From: Thornton, Marisa on behalf of Collections.SubW
Sent: Wednesday, December 03, 2014 9:00 AM
To: Thornton, Marisa
Subject: Fw: EPA hosting conference call on Subpart W draft rule for radon emissions from uranium mills - tomorrow 11 am EDT

As you may know, EPA is proposing a draft rule **to Limit Radon Emissions from Uranium Mills.** NESHAP Subpart W is a radon emission standard for operating uranium mill tailings. In accordance with the Clean Air Act Amendments of 1990, this proposed rule would require the use of generally available control technology (GACT) to limit radon emissions from tailings at all uranium recovery facilities. Specific control technologies would be required at conventional tailings impoundments, evaporation ponds and heap leach piles. [Click here for the EPA link](#) on this draft rule.

Attached are Energy Fuels Resources (USA) Inc.'s comments on EPA's Proposed Rules for Subpart W of 40 CFR Part 61. Energy Fuels is the largest conventional producer of uranium in the United States and would be directly impacted by the implementation of revised Subpart W regulations. Thank you for your consideration of our comments and concerns.

Fig.1 - Uranium Mill Tailings Piles (Courtesy, EPA Radiation Protection, Uranium Mill Tailings).
Last visited: September 21, 2014
URL: <<http://www.epa.gov/radiation/docs/radwaste/402-k-94-001-umt.html>>

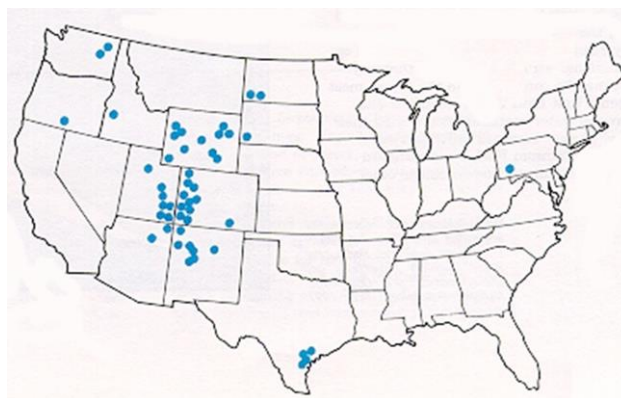
finds the lack of clarity regarding dimensions for the disposal impoundments and total allowable number of disposal sites as unacceptable. As the regulatory language is currently written, the continuous disposal work practice standard could result in the unintended use of operating mill tailings as permanent repositories for vast quantities of radioactive mill tailings. As such, the NTAA recommends that EPA revise the regulatory language for the continuous disposal approach to specify the dimensions and number of disposal cells allowed at a mill tailings facility.

more so than the depth or volume of the impoundment.” Proposed Rule at 25393. Thus, 2, 40-acre impoundments would likely have a greater Rn-222 emission potential than a single 10 acre section of disposal cell.

Fig. 2. Uranium Locations from EPA Database and Federal Lands. Note proximity of Bureau of Indian Affairs lands (indicated in green) to EPA Uranium Location Database locations throughout the Western U.S.

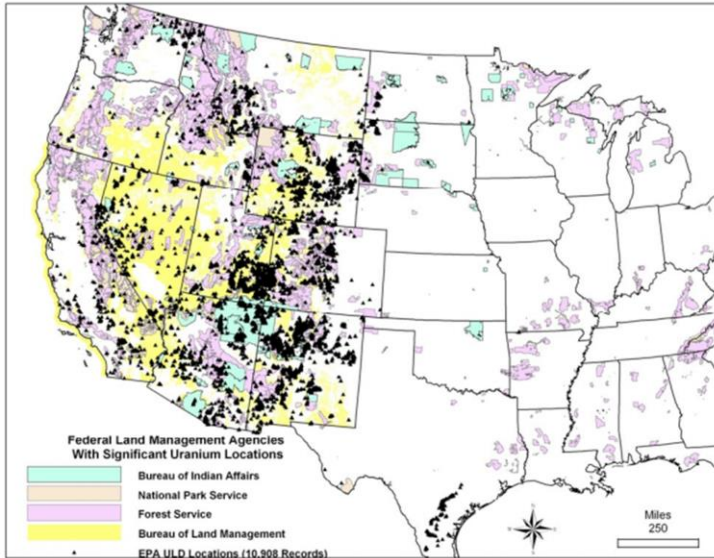
EO 13175 in the Proposed Rule, particularly in light of the historic and ongoing environmental contamination that has resulted from uranium operations in and around Indian Country (see Figures 1 and 2).

Figure 15: Radon Flux as a Function of Moisture Saturation and Moisture Content

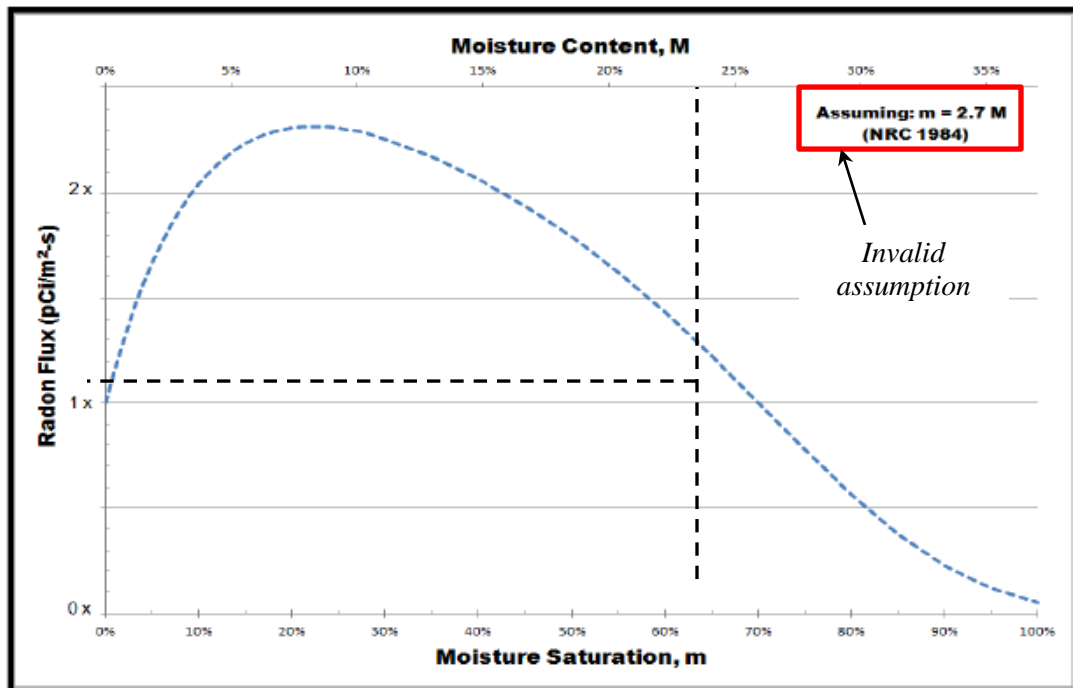
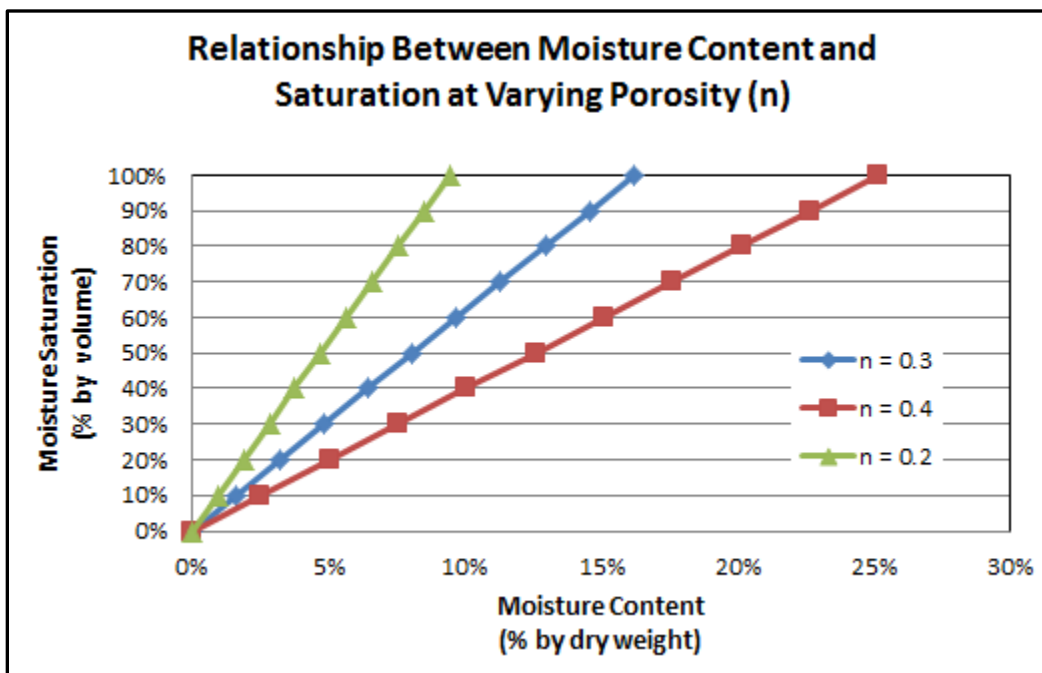
- The terms “moisture saturation” and “moisture content” are used interchangeably in the document, though they have fundamentally different meanings. Moisture saturation (S) represents the “volume” of water filling the available void space, and is typically represented by a maximum of 100%. As discussed above, moisture content is a function of the “mass” of water contained within a mass of solids, and, assuming a moisture saturation of 100%, the potential maximum moisture content of a soil decreases with decreased porosity.

- Research presented by Rogers & Nielson (1991) and NRC (1984) show that above about 30% moisture saturation, the radon emanation coefficient is unchanged by increasing moisture, while the radon diffusion coefficient continues to decrease. The EPA used the Rogers & Nielson (1991) empirical relationship for the diffusion coefficient, combined with an assumed porosity of 0.39 and an approximation of the Vitro Sand emanation coefficient to calculate the total effect of moisture on the radon flux, shown below:

- Based on the above evaluation, the EPA indicates that a moisture saturation of 70% or greater is less than the flux at zero moisture, and that at a porosity of 0.39, the corresponding moisture
